GM SERVICE AND PARTS OPERATIONS  
DCS2082  
URGENT DISTRIBUTE IMMEDIATELY

Subject: 08205 Product Safety Recall  
Fuel Tank Housing May contact Frame Side Rail

Models: 2008 Chevrolet Express  
2008 GMC Savana  
139" Wheel Base Cutaway

**SUBJECT:** Fuel Tank Housing May Contact Frame Side Rail

2166613

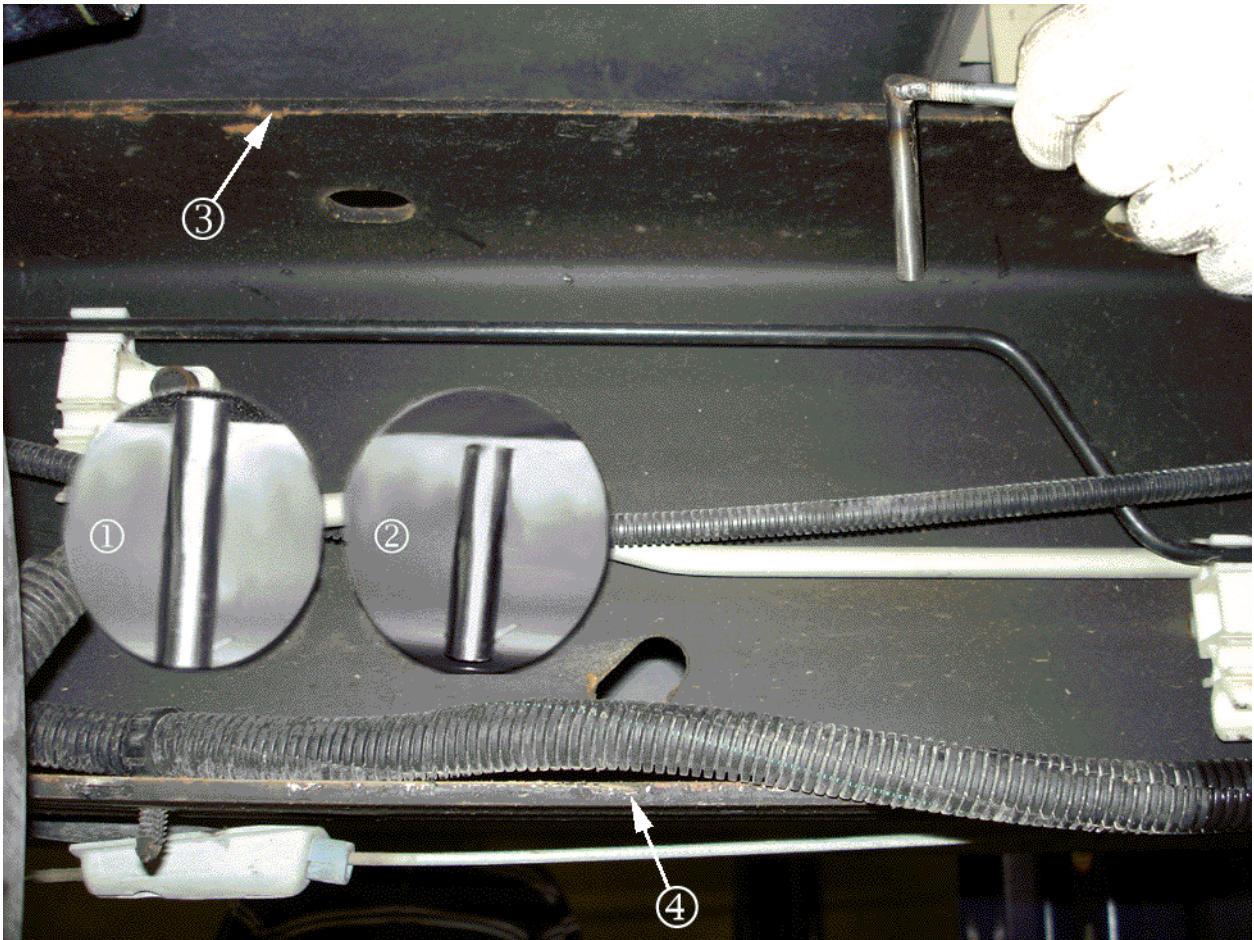
**Important:** There are two fuel tank flange access areas located on the driver's side of the vehicle. Perform the frame side rail inspection at the rear tank flange area (2) only. Do **NOT** inspect the frame side rail at the front fuel tank flange access area (1). Refer to the illustration to view the tank inspection area (3). The spring perch is near the rear fuel tank flange area.

2166607

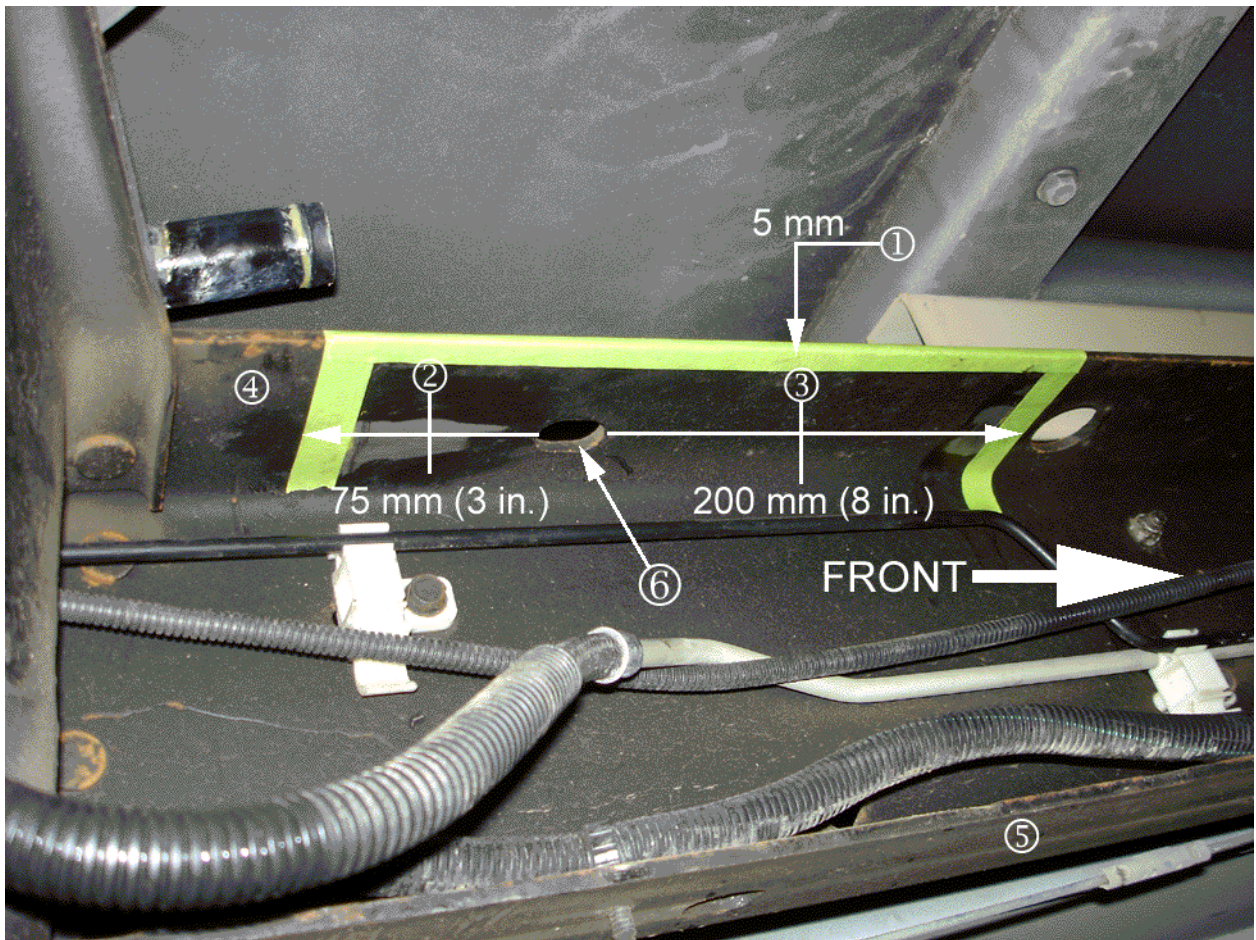
**Important:** Make sure the inspection pin is flat against the frame side rail web and **NOT** in the radius of the bend. An extra piece of steel stock was welded to the inspection pin to create a handle. This inspection pin handle is not required to perform the inspection.

4. Inspect the width of the frame side rail on the driver's side of the vehicle, near the rear fuel tank flange access area of the frame side rail. Insert the inspection pin along the width of the frame side rail as shown in the illustration. Inspect the top of the frame side rail (3) only. Do **NOT** inspect the bottom of the frame side rail (4).
  - If the inspection pin is equal to or longer than the width of the frame side rail (1), then the frame side rail is within the desired specification. Proceed to Step 14.
  - If the inspection pin is shorter than the width of the frame side rail (2), then the frame side rail is too wide and must be reworked to the proper width. Proceed to Step 5.
5. Make sure the fuel filler neck, lines, and harnesses, etc., in the rework area are protected before you perform the rework (i.e., use a welding blanket, metal guard, etc.).
